Amersham Corporation
40 North Avenue
Burlington, Massachusetts 01803
Telephone (617) 272-2000

23 August 1990

Mr. Charles MacDonald, Chief
Transportation Branch
Division of Safeguards
and Transportation, NMSS
United States Nuclear Regulatory Commission
Washington, D.C. 20555

Drawing number 66025 has been revised to show the following corrections:

AS NOTED	MODEL 660 GAMMA RAY PROJECTOR SHIPPING CONTAINER DESCRIPTIVE ASSEMBLY
35/10/69 11/22/69 11/22/69	C 66025 C

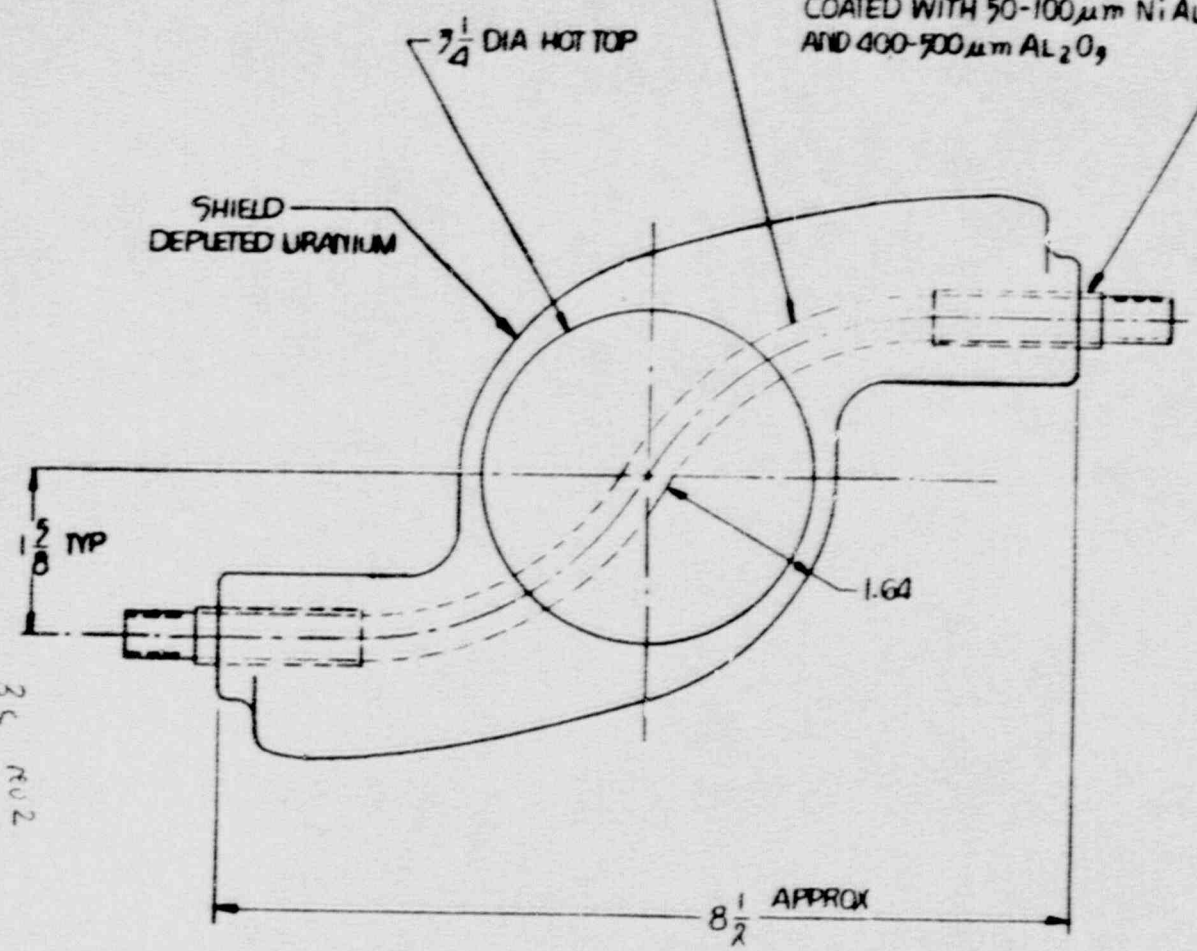
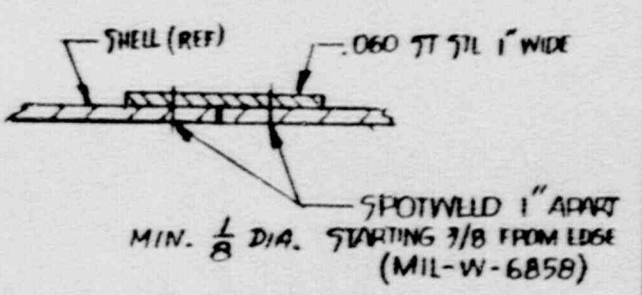
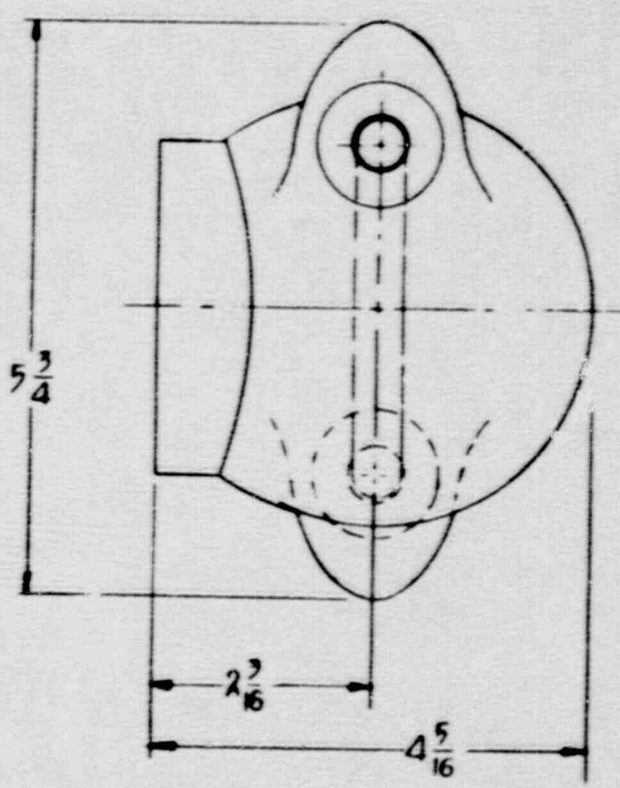
- a) A copy of Mil-Spec W-6858 has been enclosed as Appendix A, the details of the spot welding procedure are included within this specification. The welds are inspected to assure they meet the minimum requirements as specified in drawing 66025 sheet 3. This procedure is stated in Section 8.1.1.
- b) The size, type and location of the spot welds on the bottom plate.
- c) The reference to sheet 4 has been changed to sheet 3.
- d) The shell material is specified as stainless steel for the new models, beginning with serial number 4488.
